Town of Casco

Planning Board Meeting Agenda

6. 960 Meadow Road Holdings, LLC. Country Village Assisted Living - Site Plan Review
– Submission in response to public comments - 960 Meadow Road, Casco ME 04015
Map/Lot 42-19

**Re: Response to Review Comments
Country Village Assisted Living Expansion
960 Meadow Road
960 Meadow Road Holdings, LLC - Applicant**

TURNING MOVEMENT EXHIBITS

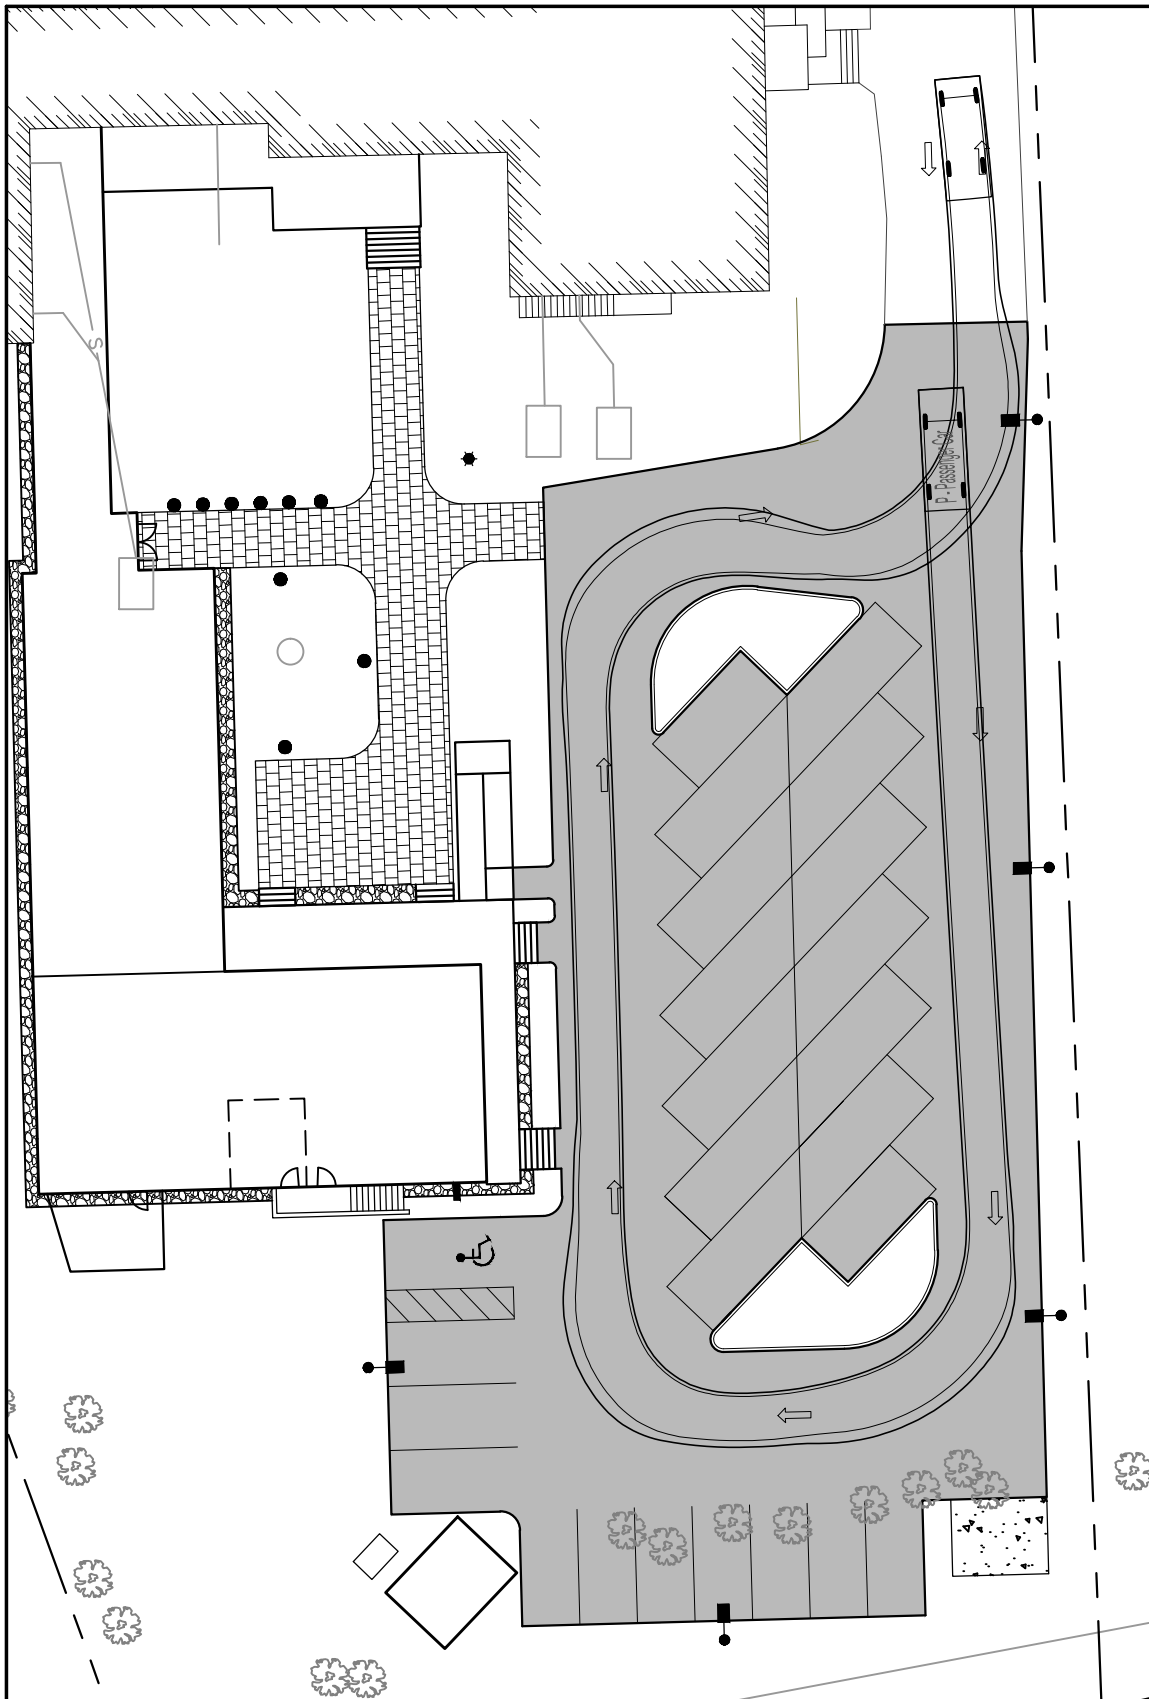
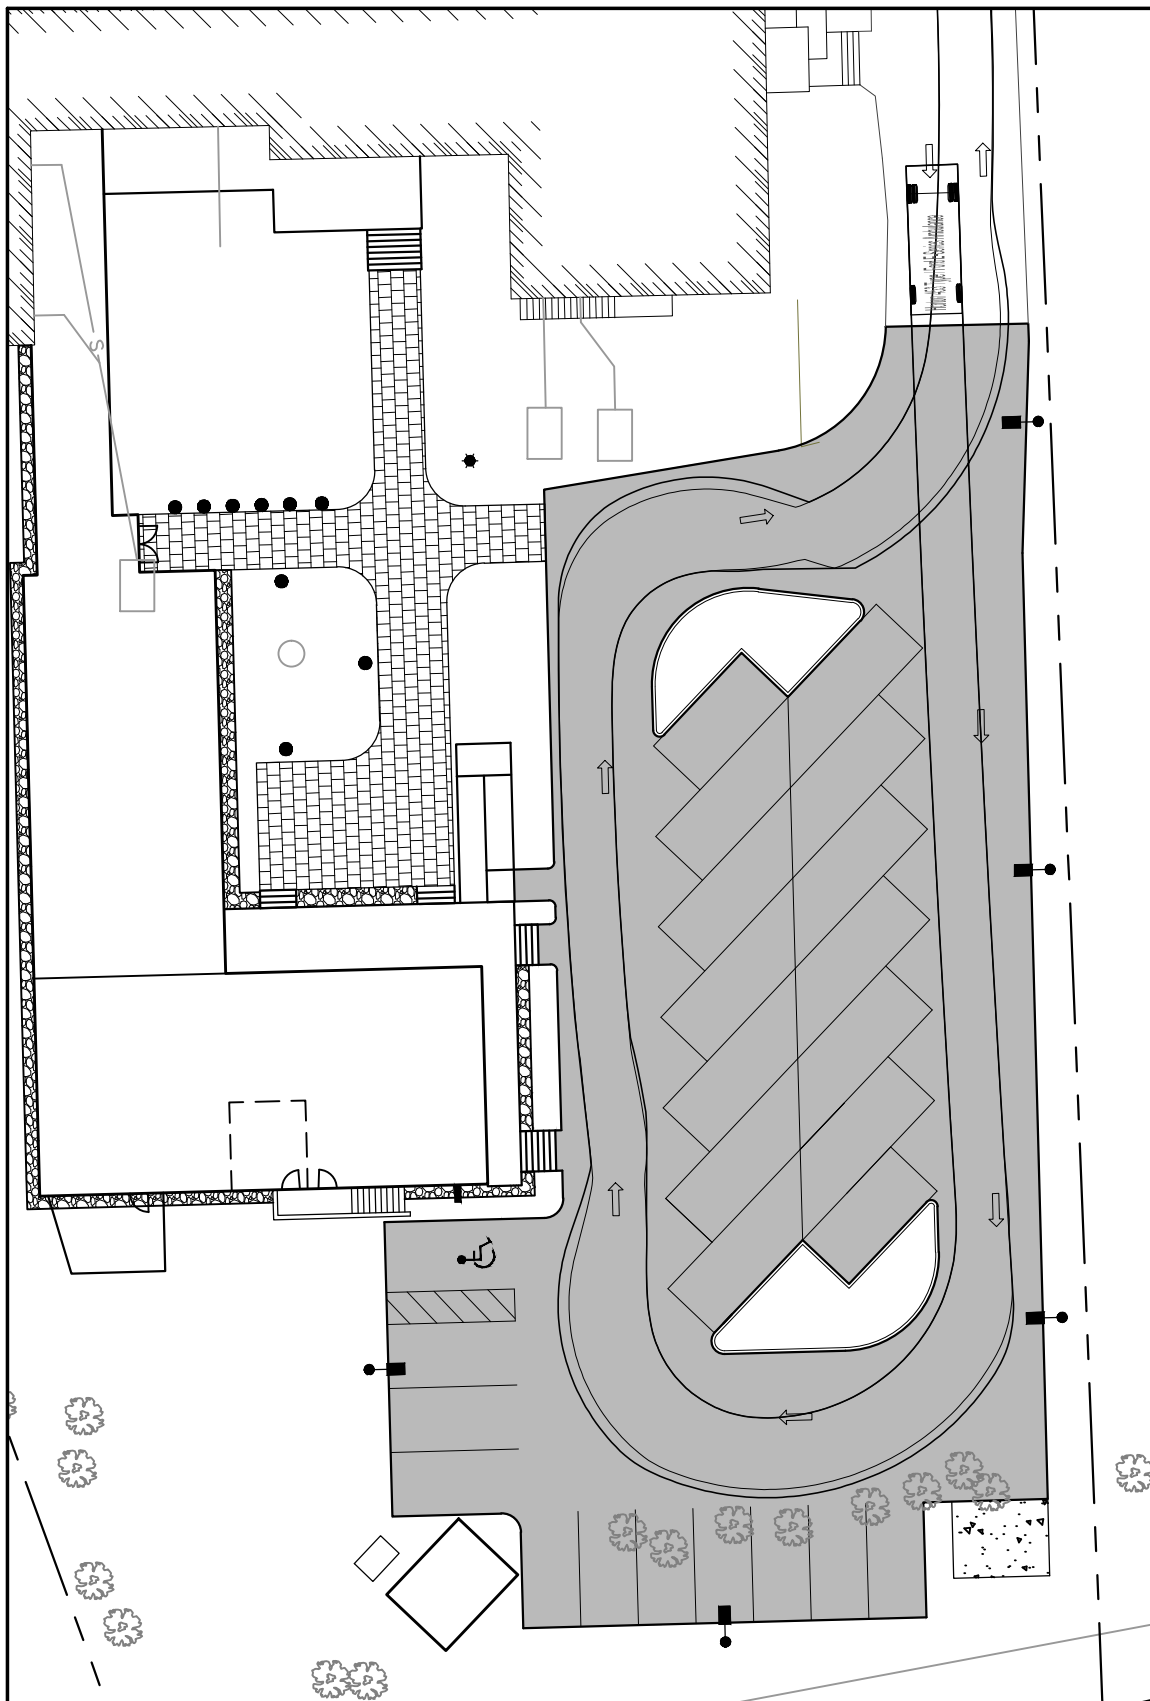
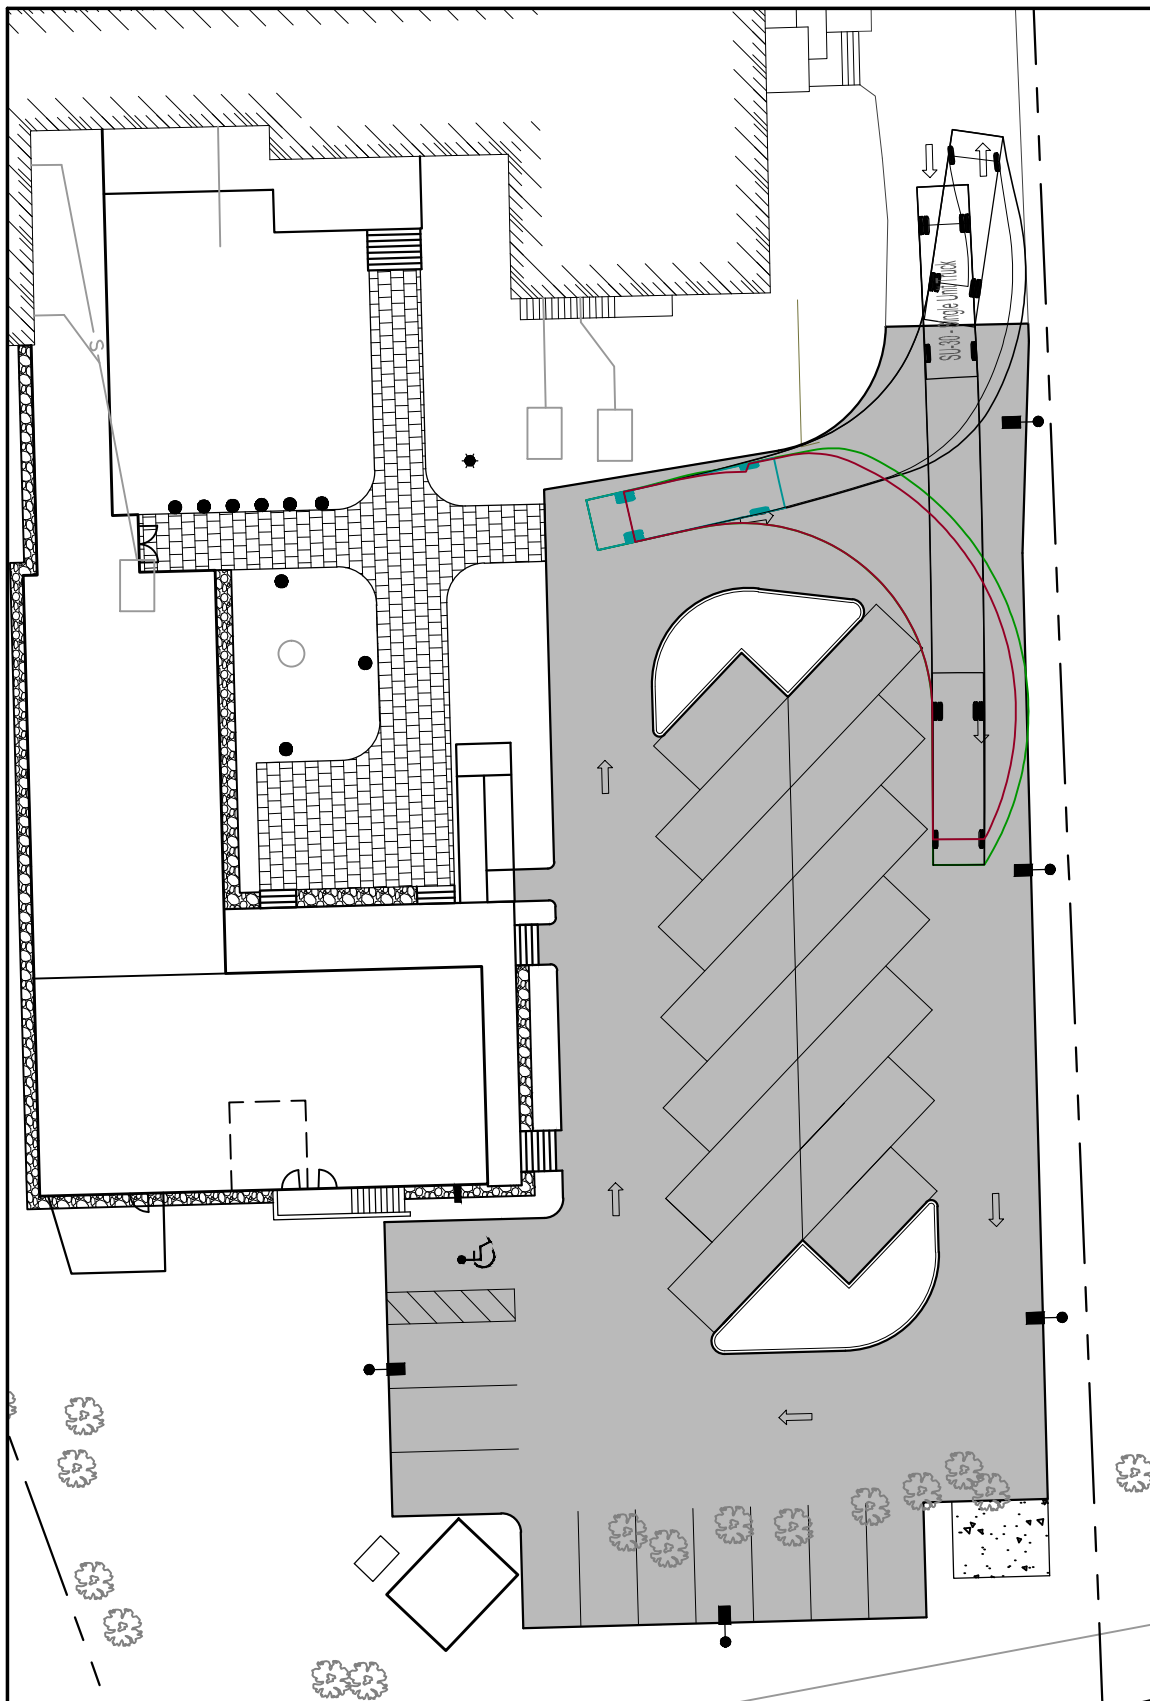
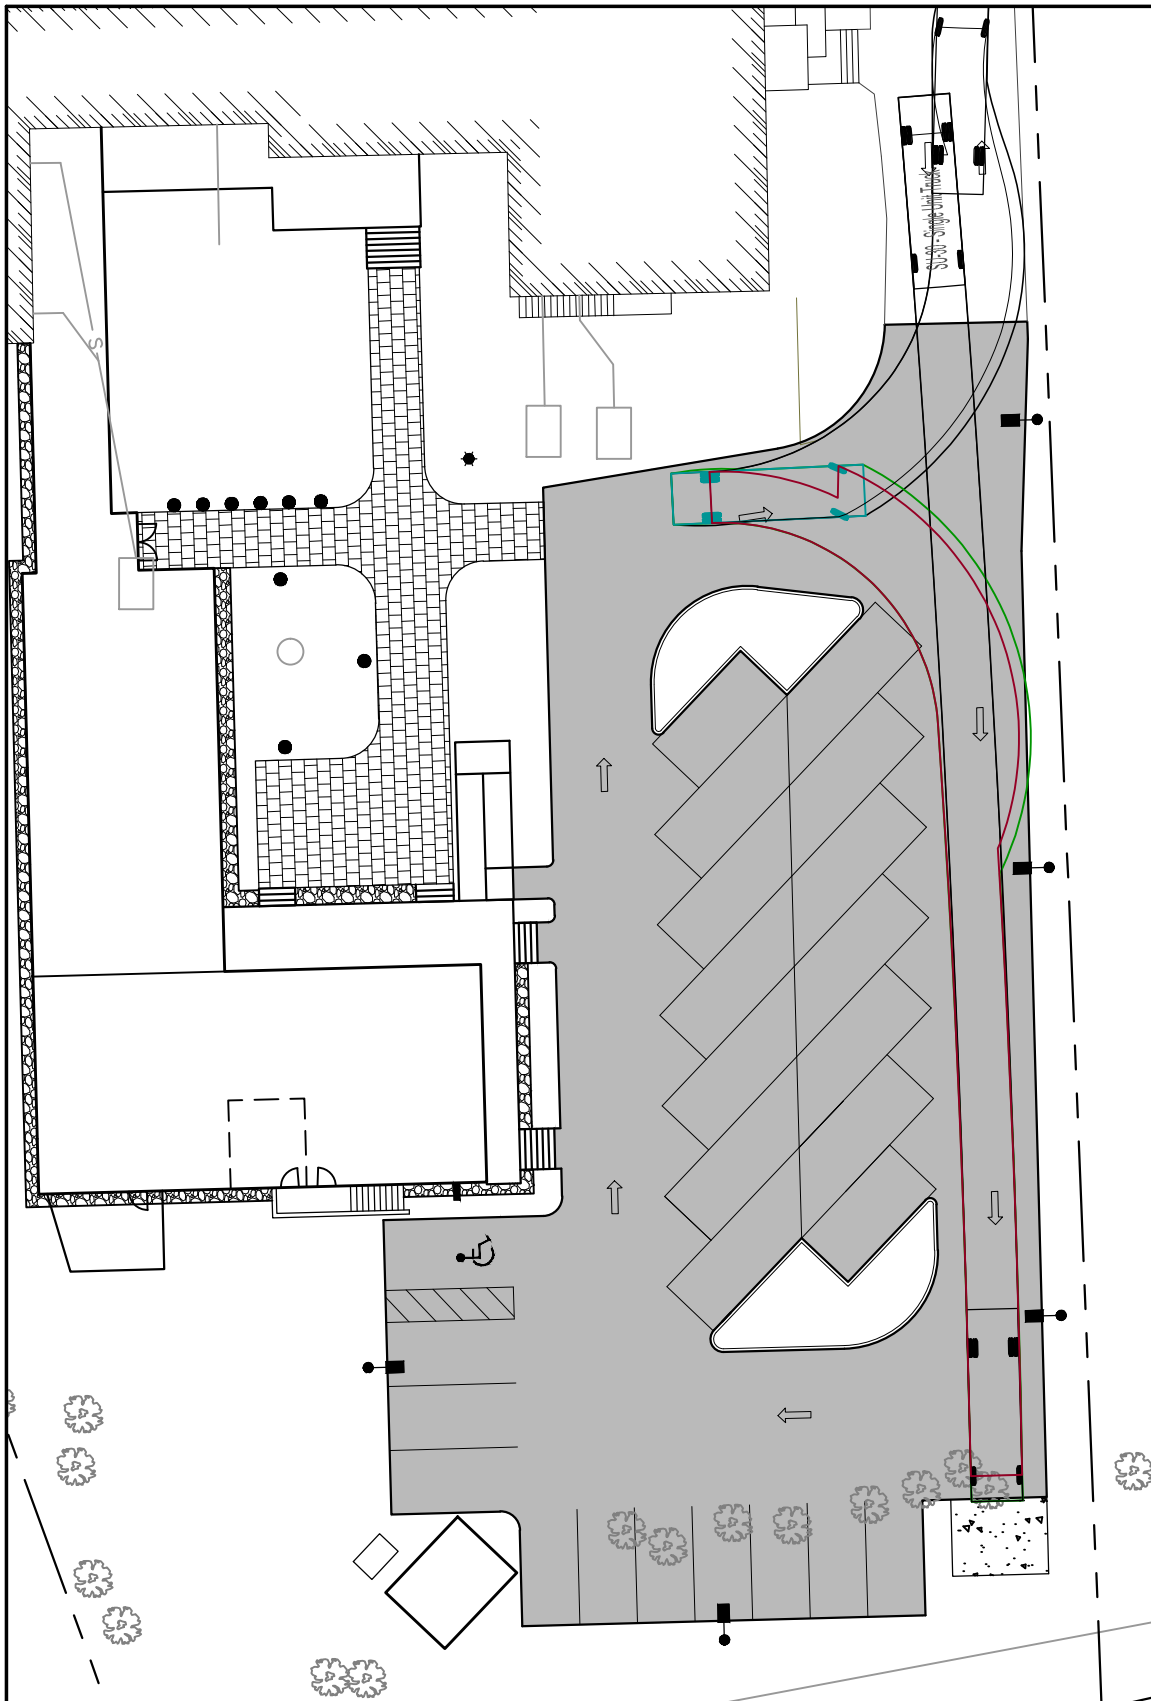
Comment 7 - The turning radius for vehicles around the rear island is tight and the lane narrows to 16 feet due to the angular parking. A turning template should be shown to see what the largest vehicle is that can manipulate the turn. Teh concern is larger trucks might not be able to maneuver if cars are parked there.

Response 7 – Included in this submission are turning movement exhibits for the different vehicles that would typically be onsite.
